4276A-07

S E R V I C E N O T E

HP 4276A LCZ Meter

Instructions on replacing A4Q10

Fig.1 New Transistor Mounting

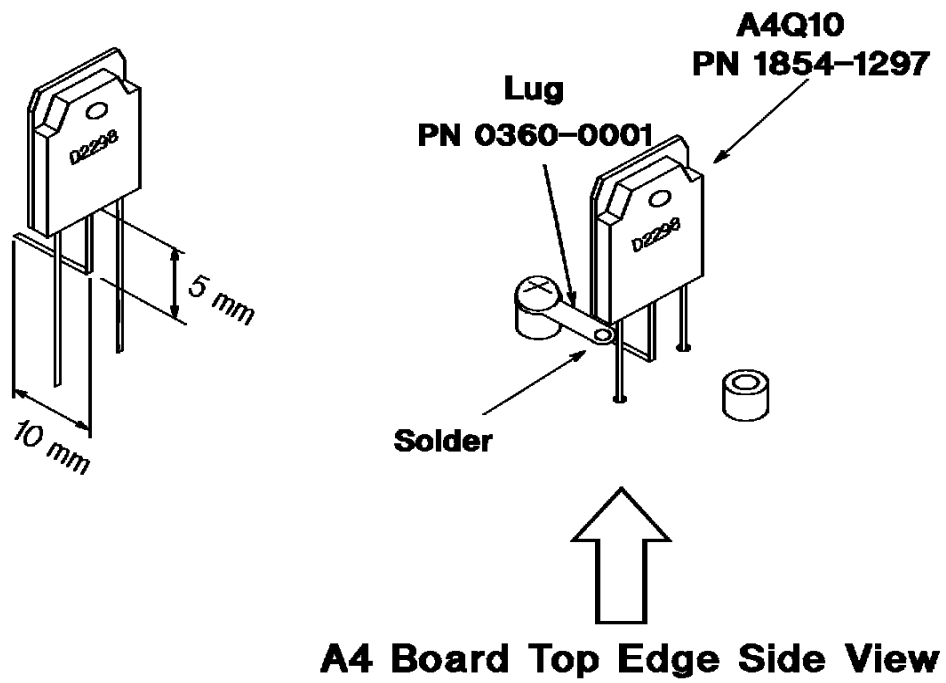
The power transistor A4Q10 on A4 power supply board has been changed. The new transistor has P/N 1854-1297 while the old transistor is no longer supplied has P/N 1854-0935. The shapes of the old and new transistors are different, so additional part and special instructions are required to install the new transistor on the old A4 board.

Install new transistor with lug as shown below.
